Submissions received after the close of the Examination

TR010056

A417 Missing Link

4. Summary of Losses Map

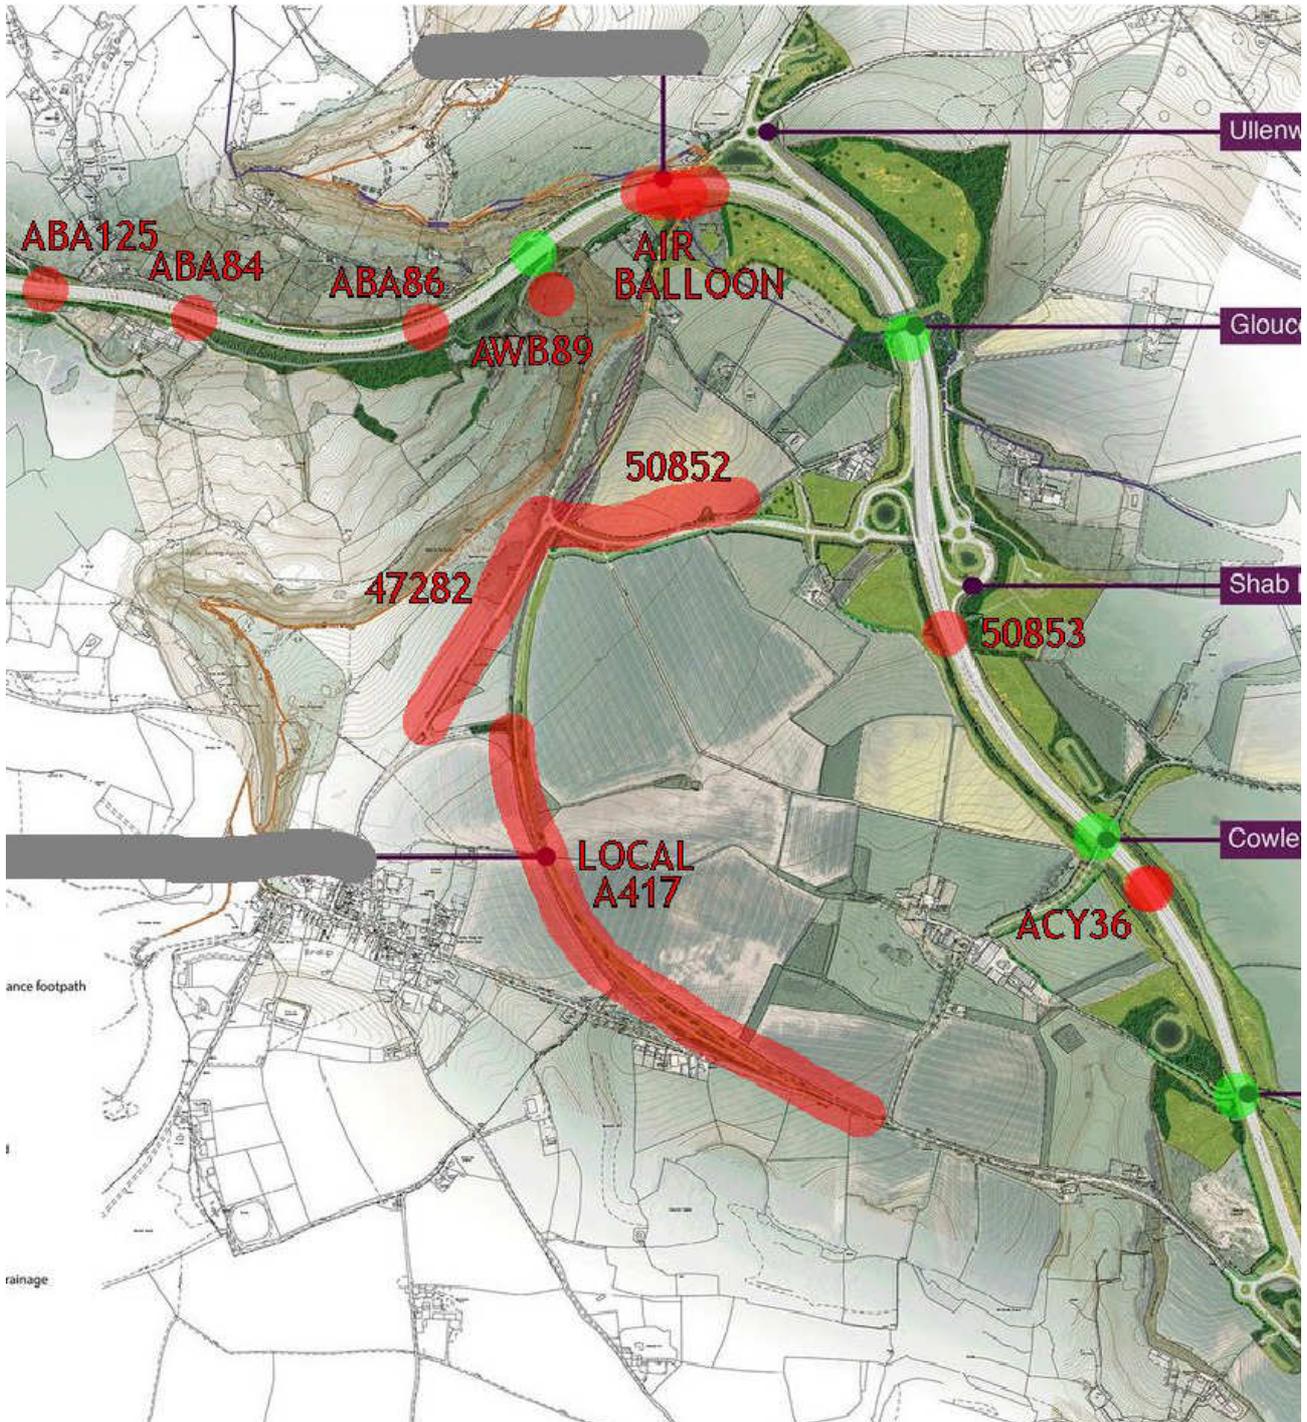
Highlight red Severance & demolition for walkers, loss of connectivity for wildlife & local communities
 Highlight Green = connectivity retained

Lost Crossings ABA125, ABA84, ABA86, Lost Air Balloon, diverted Cotswold Way

Lost connectivity AWB89 to woody access land

Lost quiet road walking parking 47282 towards view point, Lost quiet road 50852, Lost crossing 50853

Lost local A417 traffic connection between Birdlip, Stockwell, Nettleton, Cowley, Lost Crossing ACY36
 Just off Map bottom right lost local connection Brimpsfield to Cowley.

A change of use of a footpath to include other types of access would not usually be considered an enhancement such as for ABA86 an open downhill path from the Cotswold Way.

Overbridges to Cowley and Stockwell Farm shown as green should seek to maintain the current width between hedgerows as well as retaining the hedgerows and avenue of trees. Temporary access could be constructed off line, so that the completed structure keeps the current alignment.
